PREVOST

**SAFETY
RECALL**

Sr12-20

DATE : JULY 2012	SECTION : 23-ACCESSORIES
SUBJECT : AUTOMATIC FIRE DETECTION AND SUPPRESSION SYSTEM (AFSS) - REROUTING LINEAR THERMAL DETECTOR (LTD)

Engine intake side

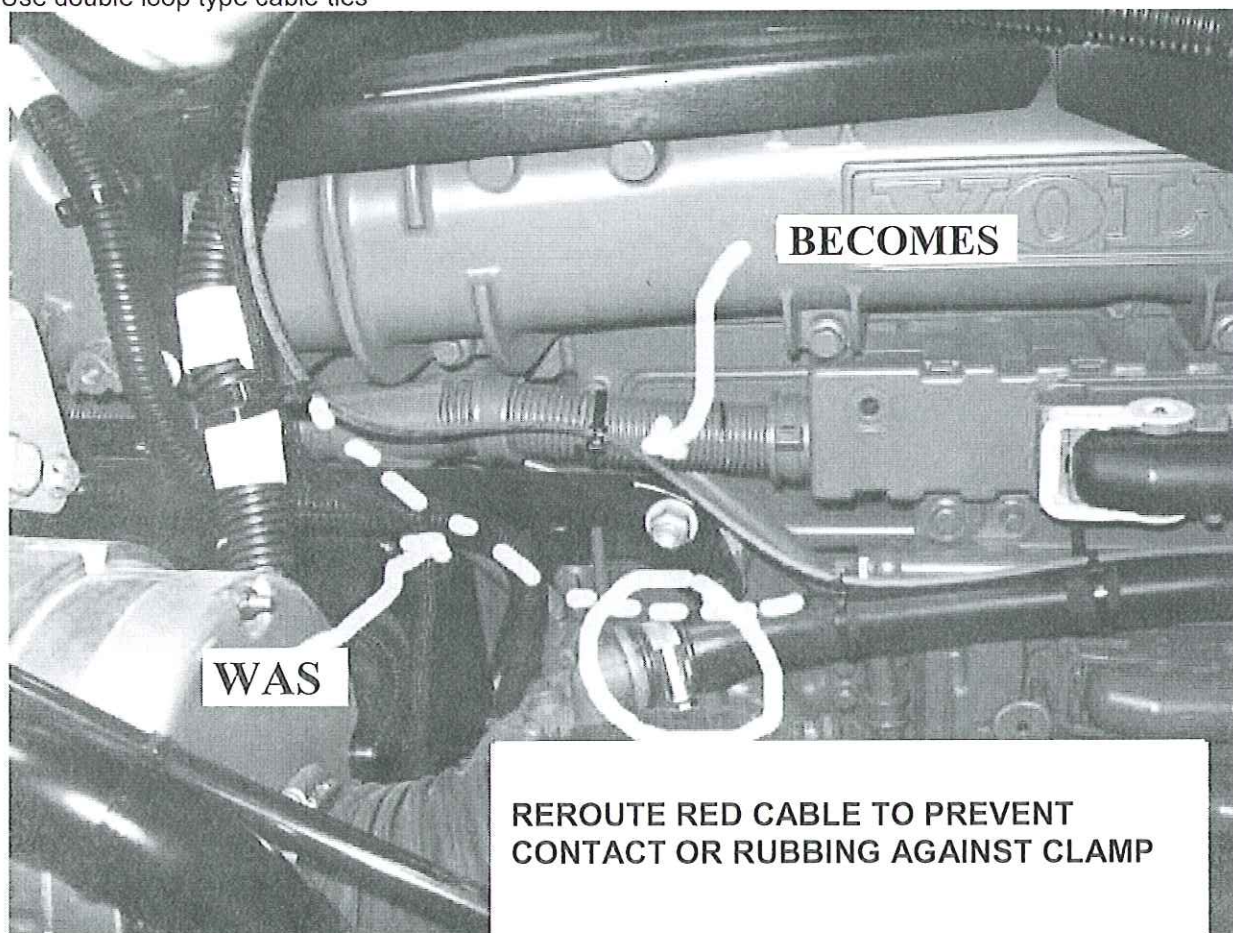
Rubbing of the linear thermal detector (red cable) against the clamp securing the Allison transmission oil level dipstick tube is likely to happen.

Reroute linear thermal detector (red cable) to prevent contact or rubbing against clamp. Fix as per picture. Use double loop type cable ties
